Customer Notification

V850ES/SG2, V850ES/SJ2

Operating Precautions

**μPD70F326xY,
μPD70326xY,
μPD70F328xY,
μPD70328xY**

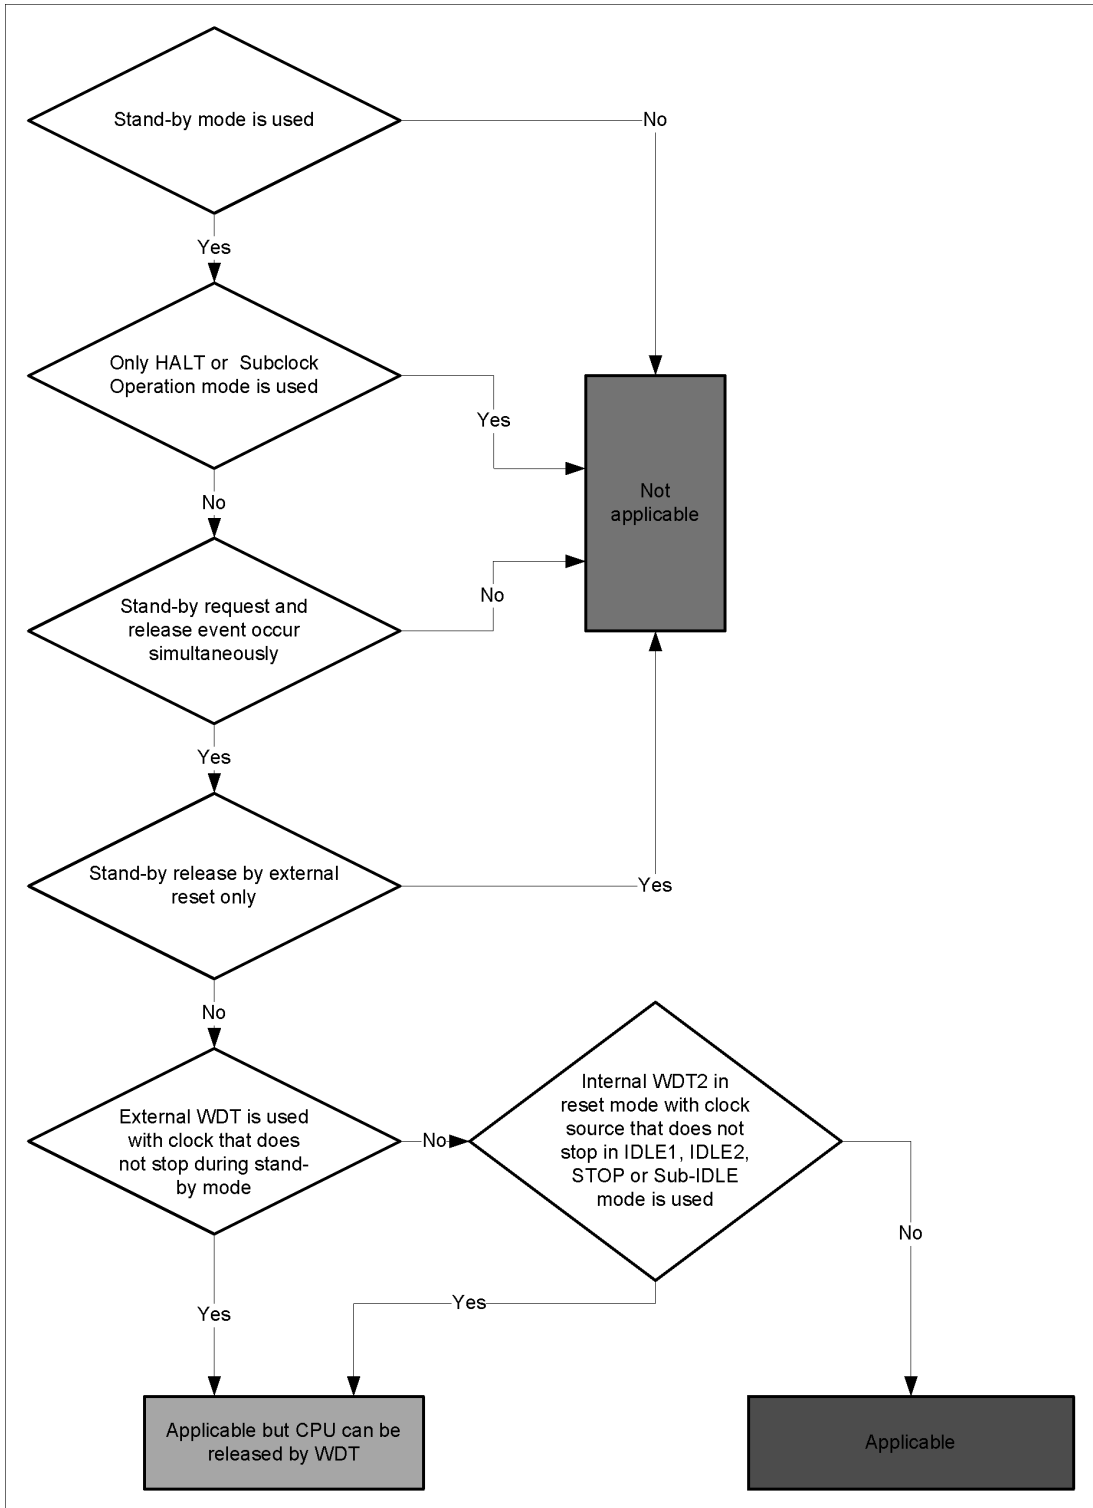
No. 3	AFCAN: Sleep Mode Wakeup (Specification change notice)
<p>4. Software Improvement Hints</p> <p>4.1 Recommended WAKEUP Handling by Software</p> <p>4.1.1 Clearing the SLEEP Mode by Software</p> <p>Within the WAKEUP interrupt routine, before accessing any other register or area of AFCAN, the SLEEP mode can be canceled by software, followed by a clearance of the WAKEUP interrupt flag.</p> <p>Doing so, the AFCAN macro will start its synchronous operation right after these accesses.</p> <p>In the following C-code example, replace the objects in “<>” brackets by the hardware locations within your implementation. Use the appropriate access types, as described in the User’s Manual.</p> <pre> WAKEUP_INTERRUPT_VECTOR --> <CnCTRL_PSMODE> = 0; /* Clear SLEEP Mode */ <CnINTS_CINTS5> = 1; /* Clear INTS5 */ ... /* following other parts of interrupt routine */ ... </pre> <p>Note: Clearing INTS5 is required to get another WAKEUP interrupt anyway, by specification.</p> <p>4.2 Other WAKEUP Handling Hints</p> <p>4.2.1 Switching off the Clock Supply to AFCAN, while in SLEEP Mode</p> <p>If the clock supply to the AFCAN macro is stopped, while it is in SLEEP mode, the synchronisation of the WAKEUP works without any restriction. To achieve this, the documentation of clock controlling unit of the target device should be consulted. Usually this is performed by setting the STOP mode of the CPU of the target device.</p> <p>However, the user has to consider, that there must not be any WAKEUP condition (dominant level on the CAN-Bus), while the software is executing between setting SLEEP mode and stopping the AFCAN clock.</p> <p>4.2.2 Using a Waiting Loop within the WAKEUP interrupt routine</p> <p>Within the WAKEUP interrupt routine, create a waiting loop, which tests the capability of clearing the WAKEUP interrupt flag within AFCAN, by checking the actual power save mode.</p> <p>In the following C-code example, replace the objects in “<>” brackets by the hardware locations within your implementation. Use the appropriate access types, as described in the User’s Manual.</p>

No. 3	AFCAN: Sleep Mode Wakeup (Specification change notice)
	<pre>do { AFCAN_SleepStatus = <CnCTRL_PSMODE> if(AFCAN_SleepStatus != 0) { /* macro is still in SLEEP mode (waiting for latency time) */ <CnINTS_CINTS5> = 1; /* repeated trying to clear CINTS5 */ } } while(AFCAN_SleepStatus != 0);</pre> <p>This improvement hint <i>cannot be applied</i>, if a CAN-Bus-Transceiver is attached to AFCAN, which generates a <i>permanent or long-lasting dominant level to the CRXD</i> AFCAN receive input, if a wakeup condition occurs. Missing another dominant edge on the bus, the synchronisation will not happen, and the loop could run endlessly.</p> <p>4.2.3 Using INIT Mode instead of SLEEP Mode</p> <p>In this case, the waking up by CAN-Bus activity must be performed via another free Pin I/O Interrupt. Probably, the RX signal of CAN must be distributed on the CRXD of the AFCAN macro, and another Pin I/O in parallel.</p> <p>Using this Pin I/O Interrupt, the AFCAN macro can be put back into the previous Operation mode.</p> <p>This implementation will <i>not</i> use the SLEEP mode of AFCAN at all, and use the INIT mode instead.</p>
